**FEDERAL HIGHWAY ADMINISTRATION
ENVIRONMENTAL ASSESSMENT AND
SECTION 4(F) *DE MINIMIS* IMPACT FINDING**

REEVALUATION

East Side Corridor (SD100)
I-90 to South of Madison Street
Sioux Falls, Minnehaha County, South Dakota

August 2016

Figure 2. Proposed changes to 2014 EA cross section to reduce borrow requirements.

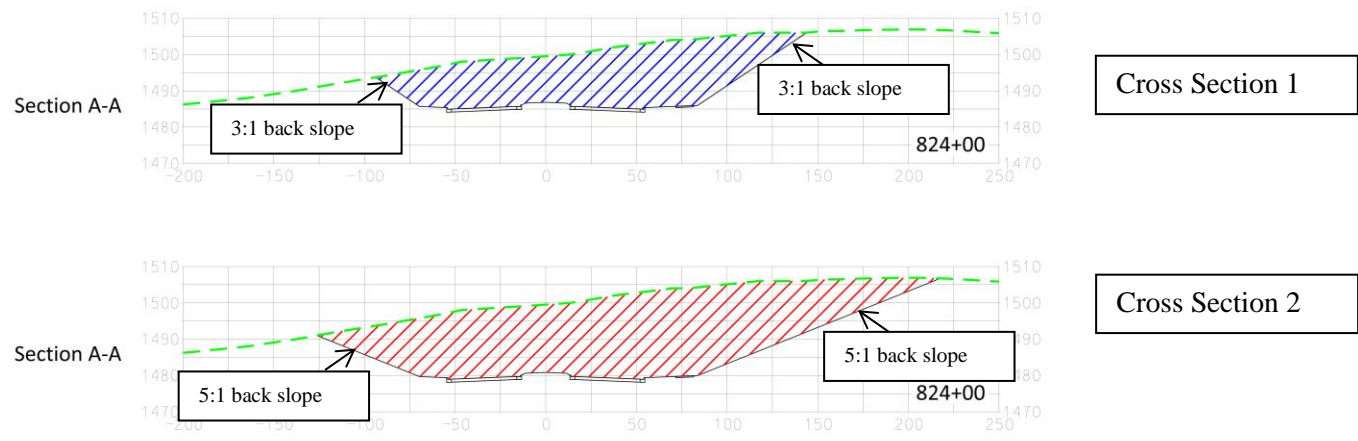
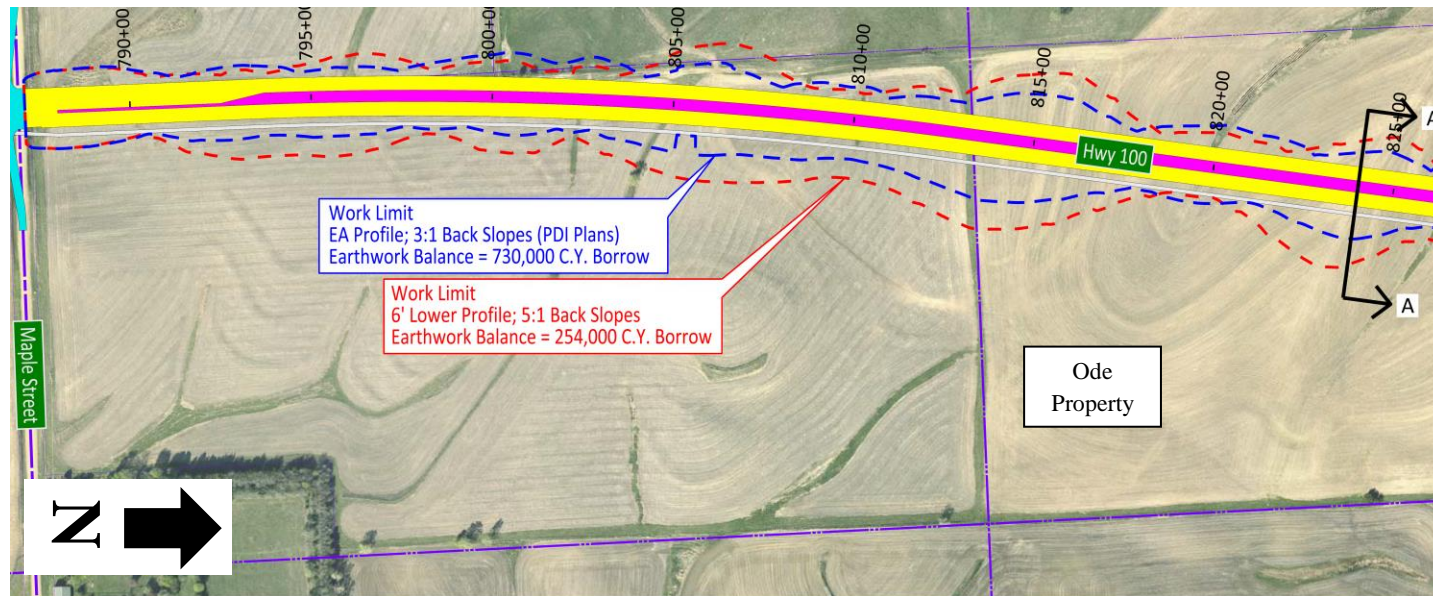
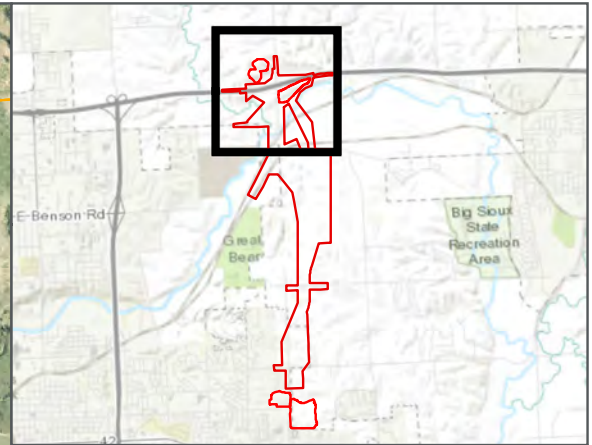
However, multiple design revisions were considered to reduce borrow requirements for SD100 from Maple Street to Rice Street (see Appendix 1). The cross section within the 2014 EA is shown on Figure 2, Cross Section 1. The revised cross section chosen to reduce borrow requirements is shown in Figure 2, Cross Section 2. Revisions to the cross section show flattening the back slope from 3:1 to 5:1. Utilizing the revised Cross Section 2 would reduce borrow from 730,000 cubic yards to 254,000 cubic yards.

- Lowering SD100 profile by 6 feet through the Ode property (see Appendix 1 and Figure 2).
- Utilizing 5:1 back slopes in cut sections instead of 3:1 back slopes.
- Identifying state furnished borrow sources in the contract.

FIGURE 3-1

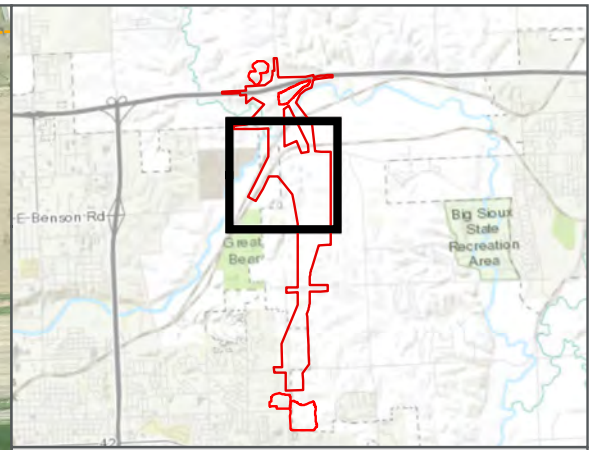
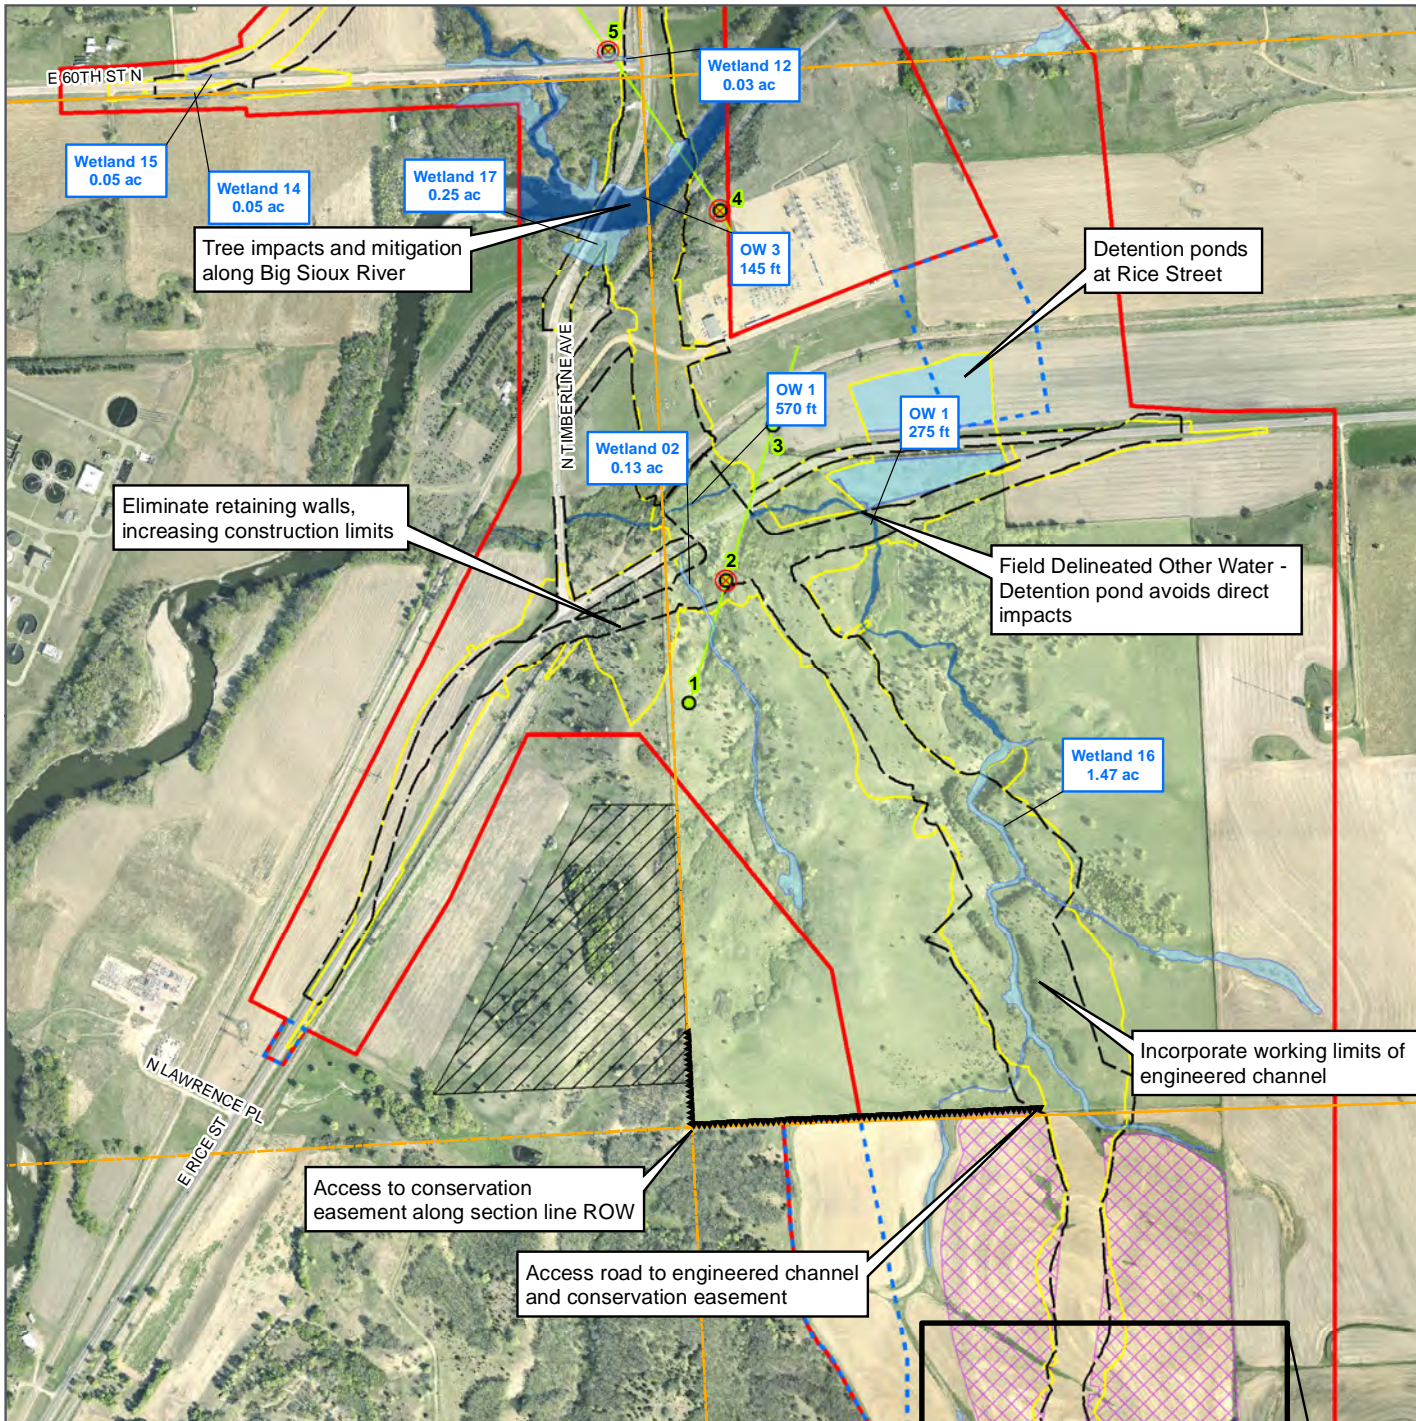
- 60th Street and Redwood Boulevard Realignment: The proposed alignment for the bridge over Slip-Up Creek was shifted to be more perpendicular to the creek, reducing the skew (see Figure 3-1). This revision would result in fewer floodplain impacts.

FIGURE 3-2

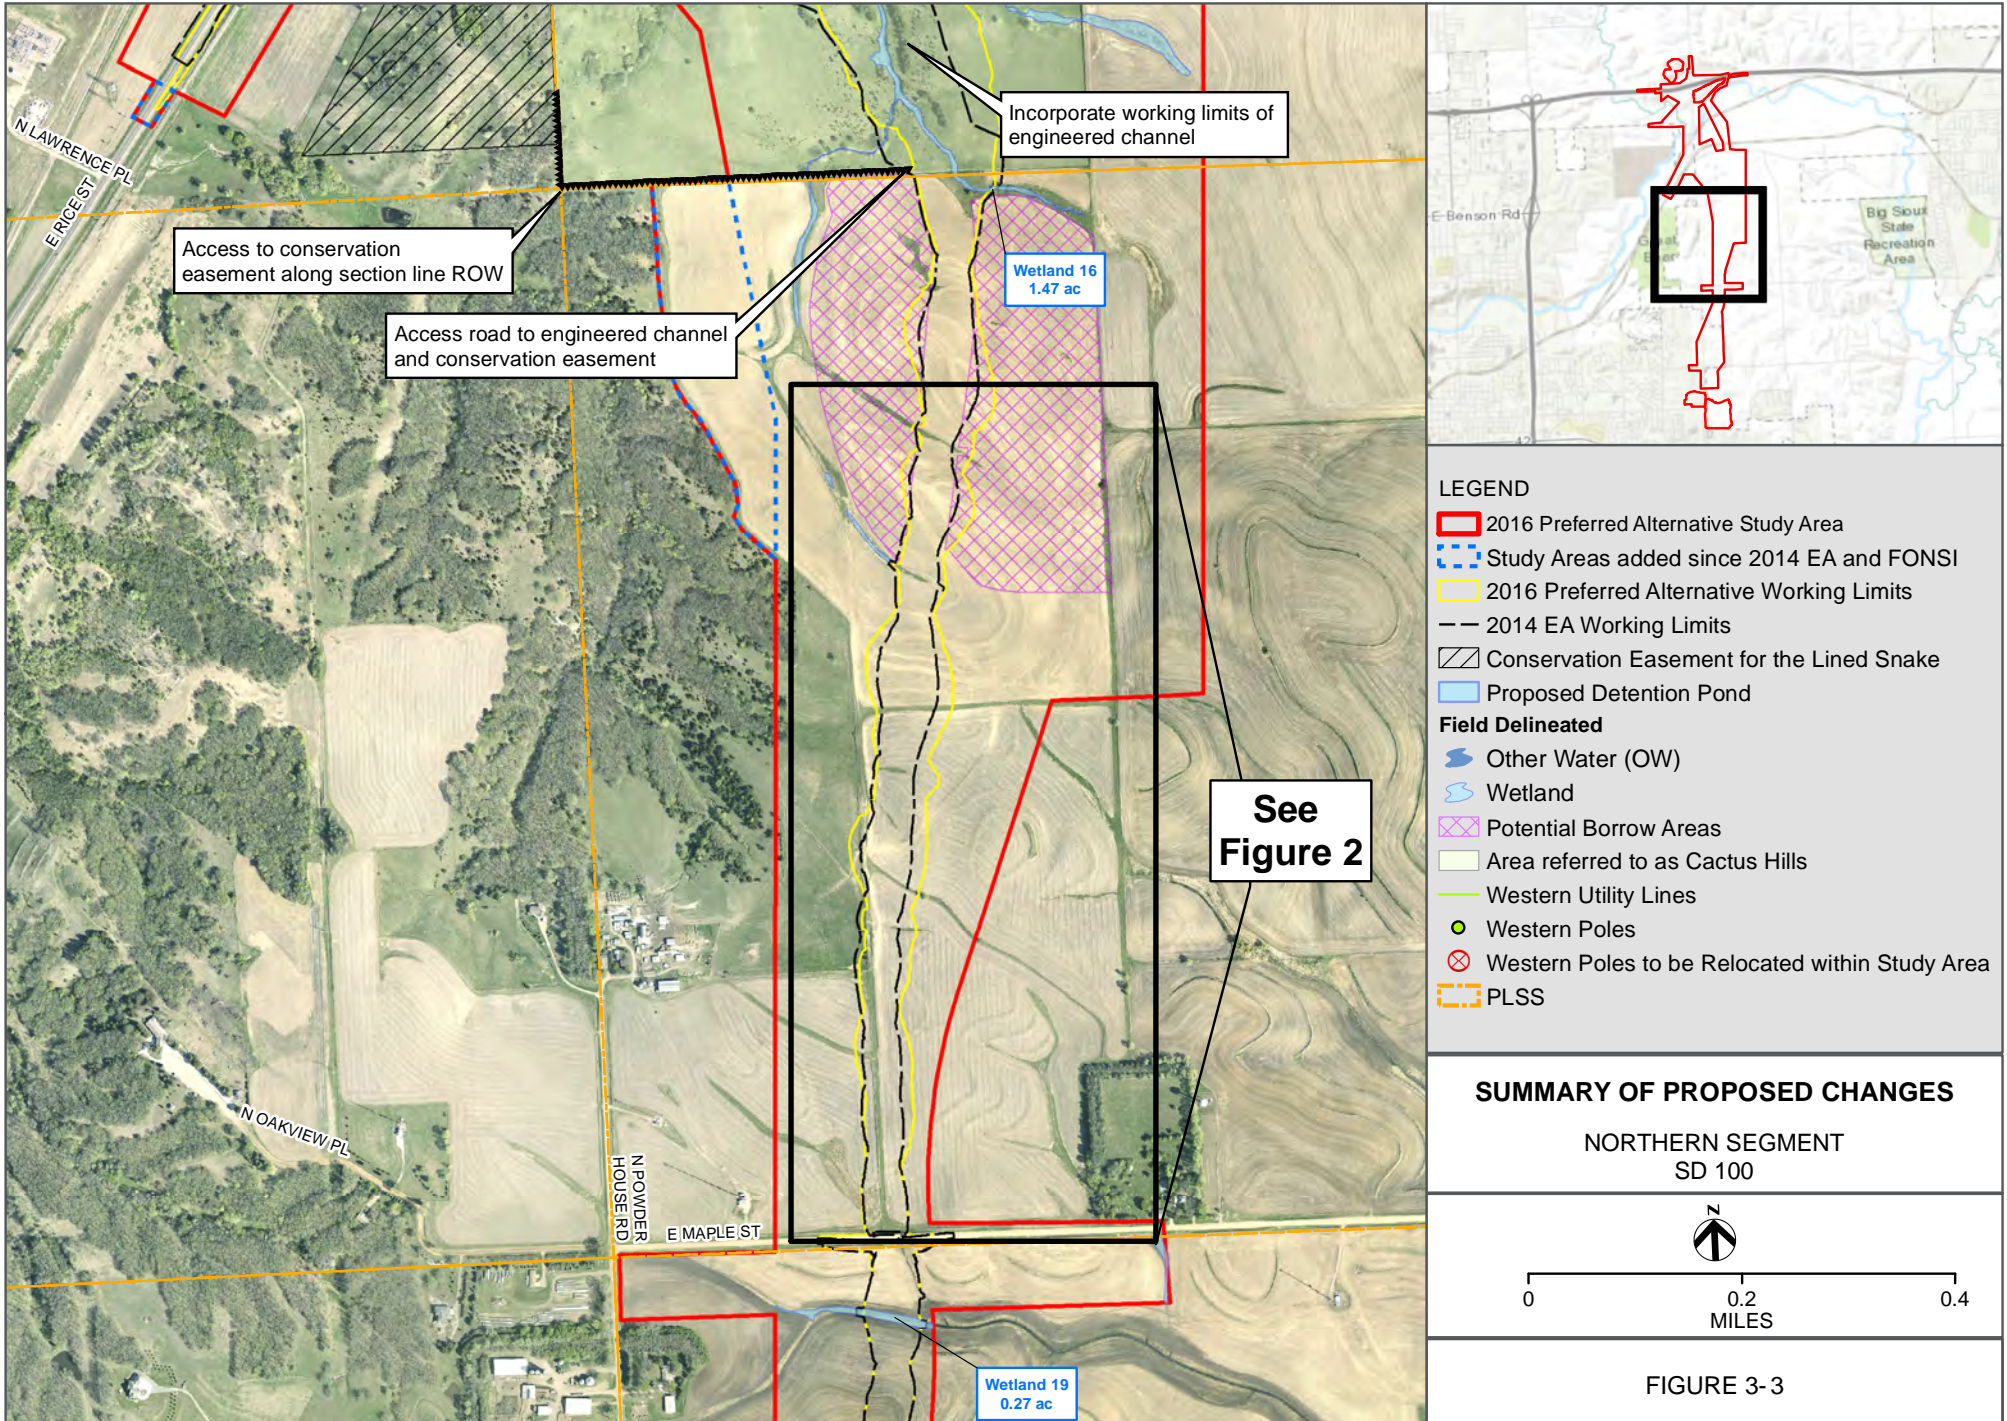
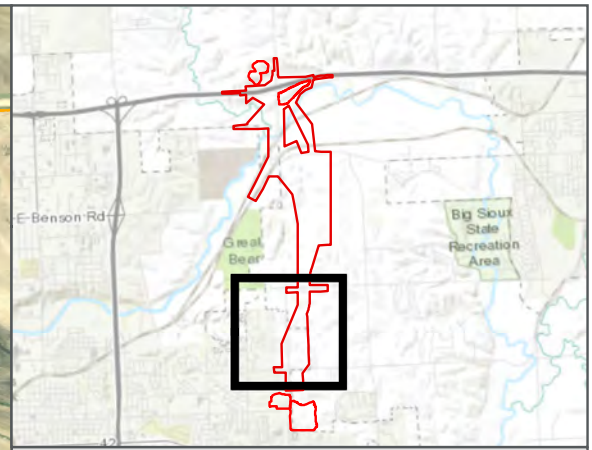
One new access road with a gated approach is being incorporated into the Project. The access would be a right in, right out design to provide access to the lined snake conservation area and the engineered channel (see Figure 3-2). The access road would be located on the south side of Cactus Hills, on the west side of SD100.

Twelve of Western's wooden transmission poles are located within the Study Area for the Project. As currently designed, the 2016 Preferred Alternative would impact up to five of these wooden transmission poles (see Appendix 4 and Figure 3-2). The estimated cost of relocating and adjusting the wooden poles is approximately \$20,000 for each pole relocation, not including any easement or ROW acquisition costs, if necessary.

- One additional access approach road on SD100. The approach road would be gated and located at approximately Station 840+00.

- Relocating or adjusting up to five wooden transmission poles (W-2, W-4, W-5, W-7, W-9).
- ROW transactions required for relocation of wooden transmission poles to locations outside of existing Western ROW.
